**From:** Cottam, Rachel  
**Sent:** Tuesday, 11 April 2023 12:05 pm  
**To:** 'Tim Walsh - Novo Group'

**Subject:** TRIM: RMA/2022/3611 - Request for further information 320A Cumnor Terrace

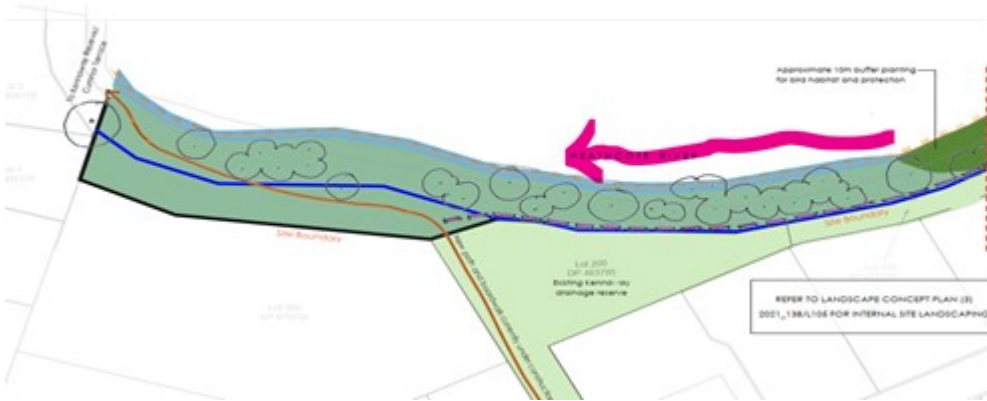
The ecologists are relatively happy with the proposed landscaping plan subject to the comments below. There may be some detailed conditions in terms of landscaping. The bird habitat needs to be extended to the H in the Heathcote river as shown above however the lizard habitat can remain as proposed on the plans. In terms of the haulage route, the area will be sheet/shaped to flow gently to the river (sloped 2% to the top of the bank) and will require the illegal channel to be filled as part of these works.
